DEVELOPMENT REVIEW BOARD REPORT

MEETING DATE: November 17, 2005

CASE NUMBER/ PROJECT NAME	88-DR-2005 ASU-Scottsdale Center for New Technology and Innovation Phases I & II		
LOCATION	Southeast corner of Scottsdale and McDowell Roads		
REQUEST	<p>The applicant is requesting approval of a site plan, floor plans, elevations, landscape plan, and lighting plan for Phases I and II of the ASU-Scottsdale Center for New Technology. Pursuant to zoning case 26-ZN-2005, the City Council will be acting as the Development Review Board for this first submittal. The Board will be making a recommendation to the Council in this matter and will be the reviewing authority for future phases.</p> <p>Also requested is approval of "Skysong," an architecturally integral shade structure with fabric mesh ranging in heights up to approximately 80 feet and structural support poles up to approximately 110 feet. Skysong is a free-standing ornamental monument which the zoning ordinance and amended development standards adopted for this project require the City Council to approve if the height is above 60 feet. The Development Review Board will be forwarding a recommendation to the Council regarding this element.

SKYSONG SECTION

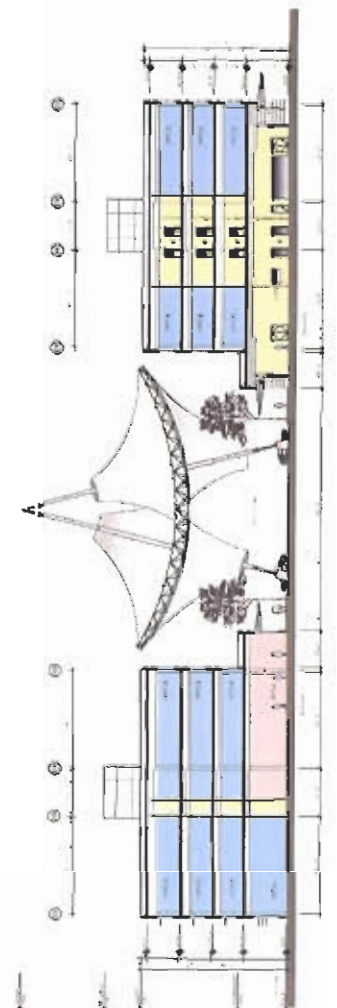
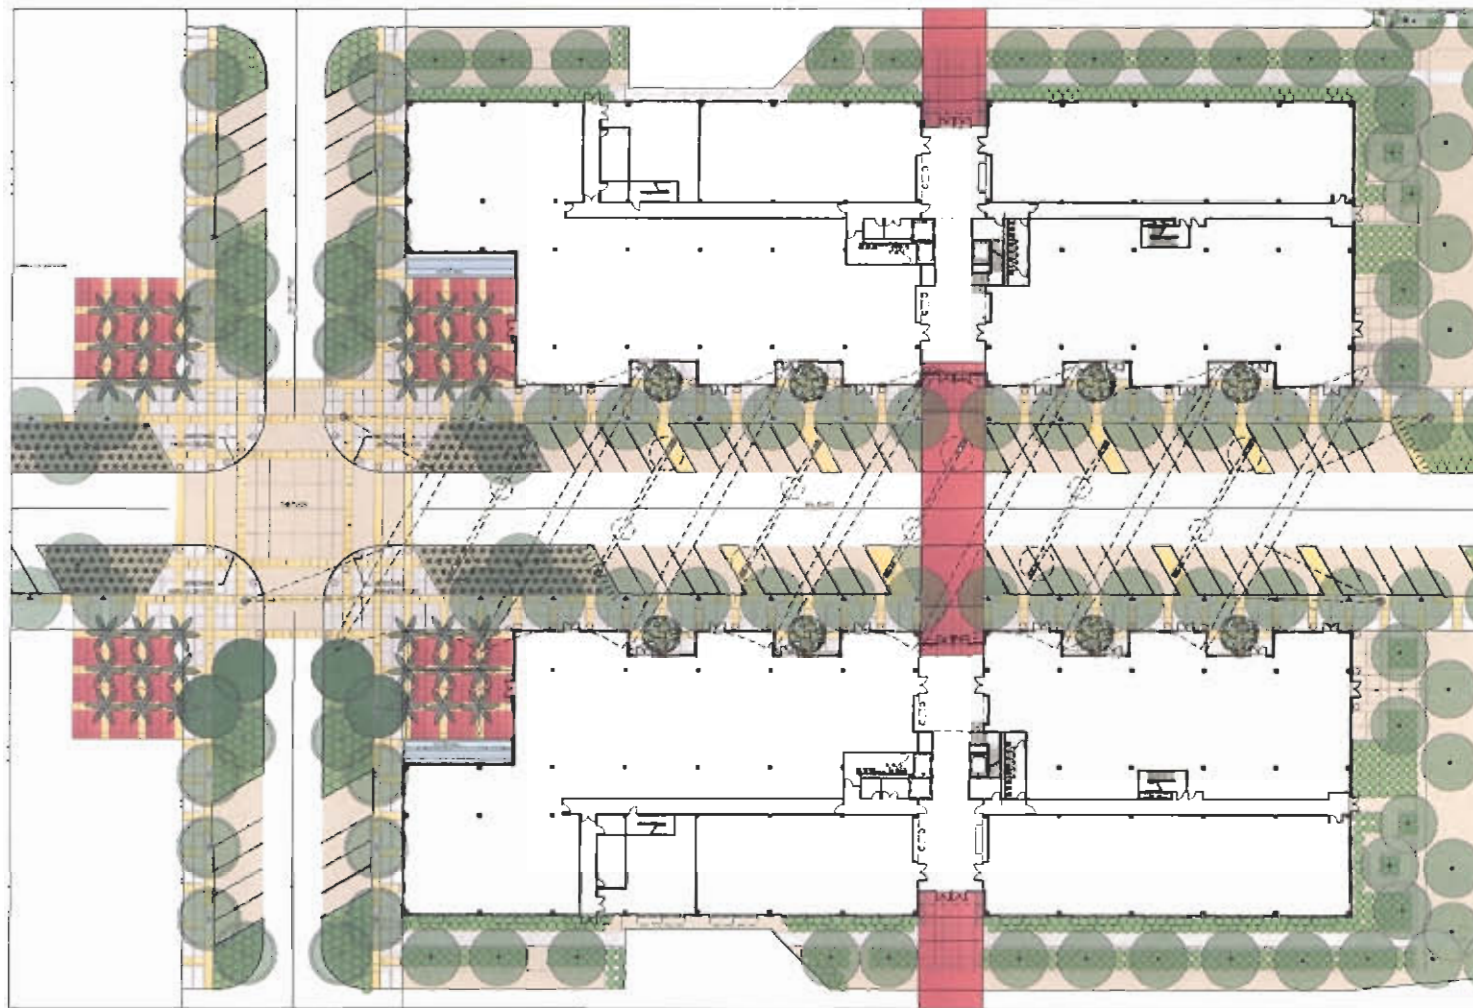
4. Further details are required regarding the location of the structure to ground tensile supports of Skysong. These details will be provided by the applicant and will be reviewed by staff to assure appropriate pedestrian clearances are provided.

Staff has raised questions regarding Skysong and how it functions in the Arizona climate. These concerns relate to its durability and long-term maintenance. Concerned citizens at the open house meeting, held on November 3, 2005, also raised these issues. Additionally, there are some questions about how the regular maintenance practices will deal with local weather (dust storms, wind, debris) and how stormwater runoff will be handled. The applicant will provide additional information on the design elements and responses to the aforementioned questions at the DRB hearing.

15. *Skysong and the maximum height shall be constructed to be in substantial conformance with the Skysong section approved by City Council.*
16. *Skysong (as shown on the site plan submitted by PEI COBB FREED & Partners Architects LLP with a staff date of 11/10/05) located east of the "Center Road" shall be constructed at the time of Phase one (1) improvements.*
17. *To assure Skysong remains a focal point and integral element of the project character, the applicant shall provide a maintenance plan for the structural and fabric elements, prior to the certificate of occupancy for the first building.*
